20250507 – May Specifications Committee Meeting

May Specifications Committee Meeting Agenda

Wednesday, May 7, 2025 @ 9:00am

Figure 601.9.3.2A: Schematic drawing of a hammerhead pier cap (a) front view (b) isometric view, a two-column pier cap (c) front view (d) isometric view, a three-column pier cap (e) front view (f) isometric view.

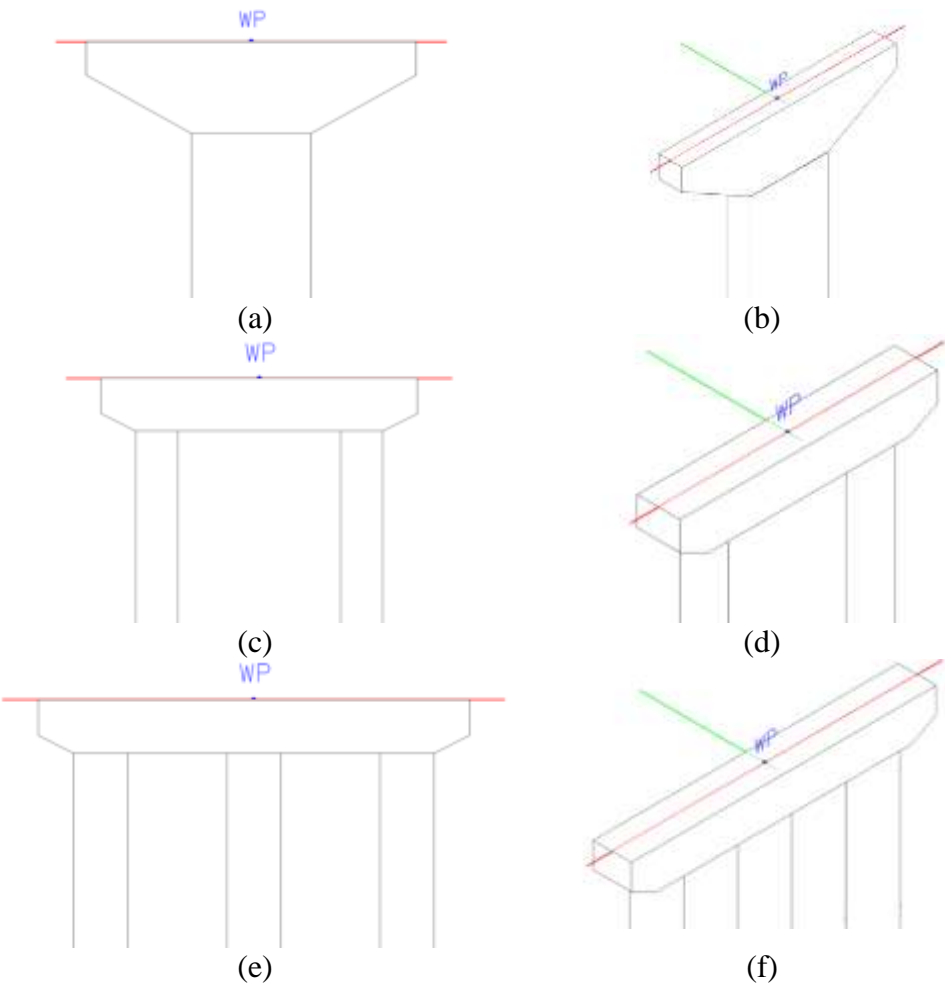
601.9.3.23-Pier Caps: Pier caps with minimum dimensions (W) per Table 601.9.3.2.1 – Table 601.9.3.2.6 shall be designated as mass concrete and require a thermal control plan meeting the requirements in 601.9.3.5. A hammerhead type pier cap with less than 14-ft in width and less than 5-ft in height shall be treated as a “14-ft Hammerhead”. A hammerhead type pier cap with less than 36-ft in width and less than 10-ft in height shall be treated as a “36-ft hammerhead”. “Two-column” pier cap shall have the span of less

than 23-ft, and height of less than 5-ft. “Three-column” pier cap shall have the span of less than 16-ft, and height of less than 5-ft. A schematic drawing of a hammerhead, a two-column and a three-column pier cap is shown in Figure 601.9.3.2A.

Figure 601.9.3.2B: Pier Cap Geometry

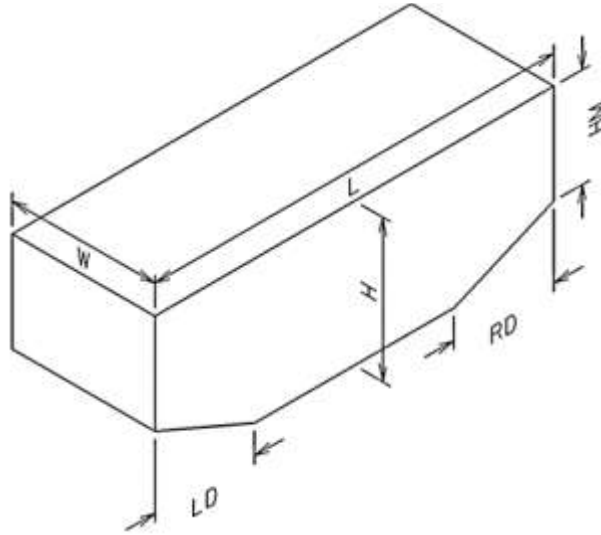
Detailed dimensions of each pier cap type are shown in TABLE 601.9.3.2. A schematic of the pier cap geometry and the parameters used in TABLE 601.9.3.2 are shown in Figure 601.9.3.2B. The dimensions shown in TABLE 601.9.3.2 remain the same and only the thickness ‘W’ changes.
